**Meeting:** Delegated Decisions by the Executive Member for Community Services on Traffic Regulation Orders

**Subject:** Bedford Road, Houghton Conquest – Consider Objections to Proposed Traffic Calming Scheme

**Report of:** Paul Mason, Head of Highways

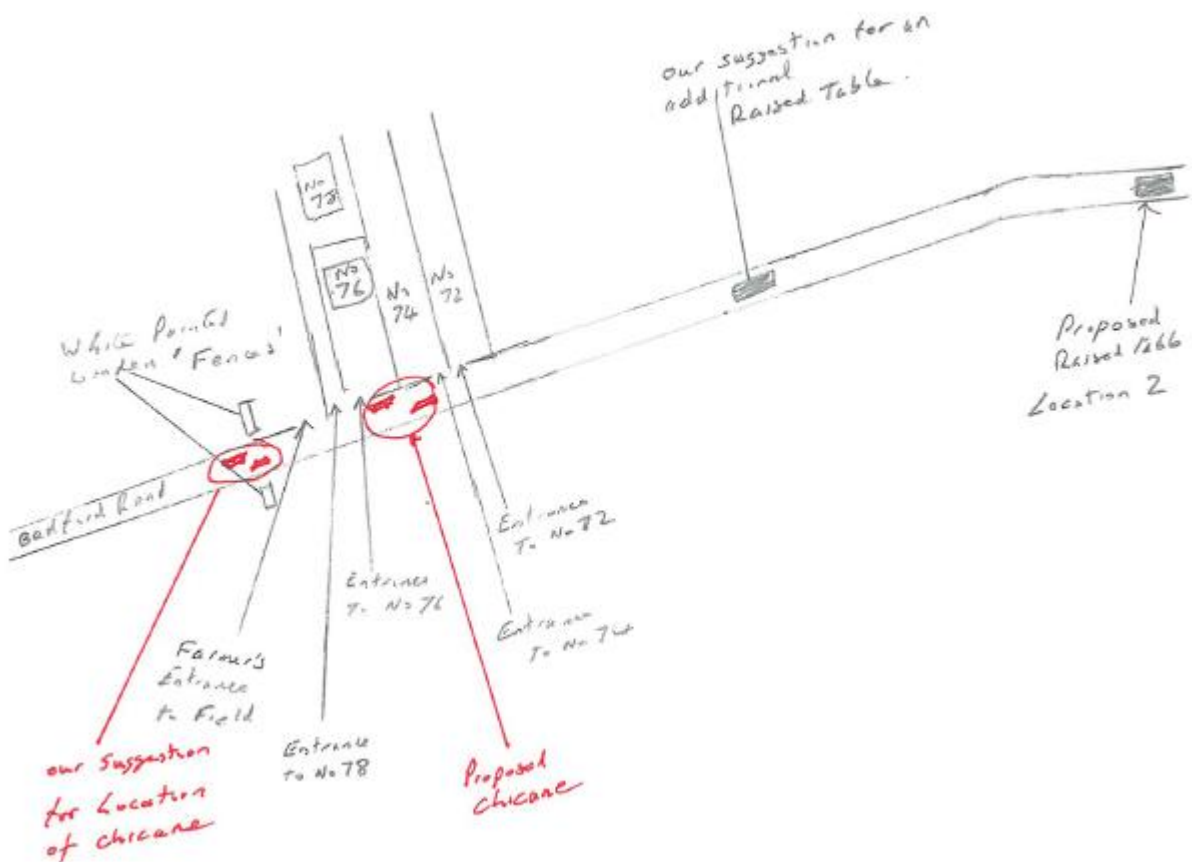
We agree that measures are required to slow traffic travelling into and out of the village along Bedford Road. However we are concerned about the positioning of the chicane outside the entrances to property nos. 78, 76, 74 and 72 Bedford Road. We believe that the positioning as proposed will interfere with the access and, particularly, the exit from each of these properties.

We consider that if a chicane is to be installed it should be moved further north-west along the road by about 50 metres to a position the other side of the white wooden structure marking the beginning of the village (see attached diagram and 2 photographs). In this position the chicane will not interfere with the access and exit from any of the properties in that area or with the farmer's entrance to his field adjacent to the entrance to property number 78.

As an alternative to a chicane, perhaps a 'Raised Table' or 'Road Humps' might be appropriate at the entrance to the village.

We also suggest that a further 'Raised Table' or 'Road Humps' should be added to the scheme at a point between property No. 78 and the Raised Table shown as location 2. It is a long stretch of road between these points and many vehicles reach speeds significantly in excess of 30mph along this stretch.
